Product Change Notification

Change Notification #: 112551 - 00
Change Title: Intel® Desktop Board DH87RL, Boxed & Bulk
PCN 112551-00, Product Material
Change Slot Connector
Date of Publication: August 29, 2013

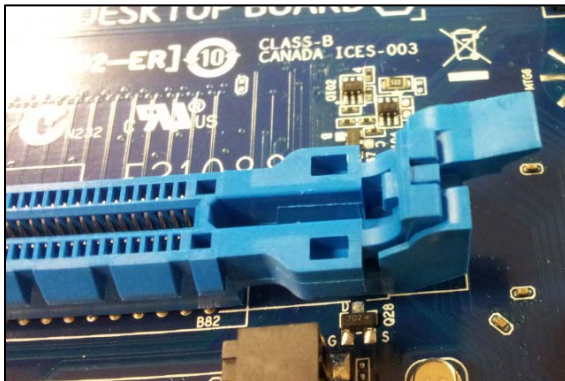
Intel will be changing the slot connector on the Intel® Desktop Board DH87RL to LOTES PCIEx16. See images below:

Current Slot Connector:

New Slot Connector:

This change has been thoroughly evaluated to ensure there is no quality, reliability, or functional implication to our customers, but Intel has noted that the effort (force) needed to seat or eject the card may vary between connectors. Intel is not recommending additional qualification of these changes on platforms received from Intel.
